LD-186-B

PENNSYLVANIA SYSTEM

"ANTIS" INTERLOCKING

LOCKING & DOG SHEET

Dog Sheet

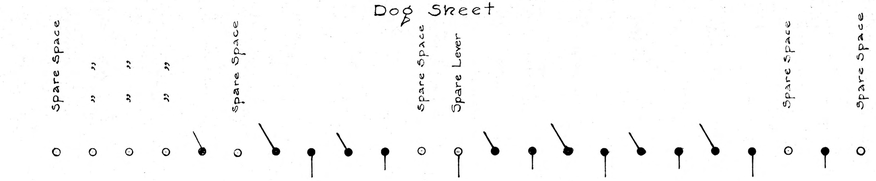
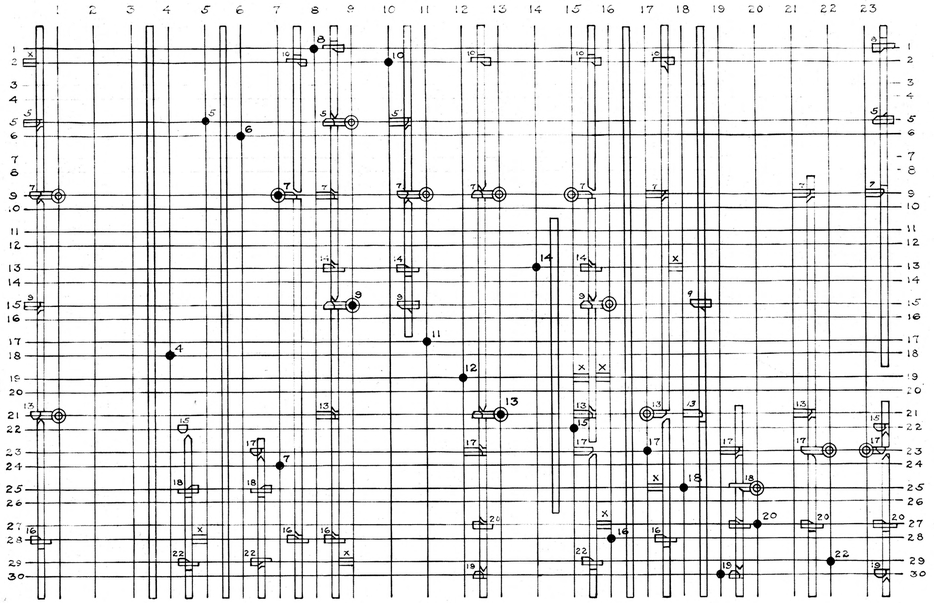
Dogs marked "X" to prevent lever being thrown to position not used

REVISED: DEC. 18, 1946. WE SIG. 3m45
PLAN NUMBER FORMERLY A-186 - LD, 3m45
7 LOCKING (7) AND 13 LOCKING (13) ADDED.
APPROVED:

Revised. Aug 3, 1929 ~~7-5-29~~ 97-LVO
Blank Cross, Locking Added To Agree With As In Service, ~~For G.S.~~ 8-8-29.
APPROVED:

Revised: July 29, 1926 ~~7-5-26~~ 97-LVO
In accordance with layout plan as revised 5-28-26.
Approved:
In Service: G.S. 5-21-26.

Revised - March 6 25 ~~3-7-25~~ 97-LVO
In accordance with revision of layout plan dated 3-5-25
Approved:
In Service: G.S. 5-18-25.
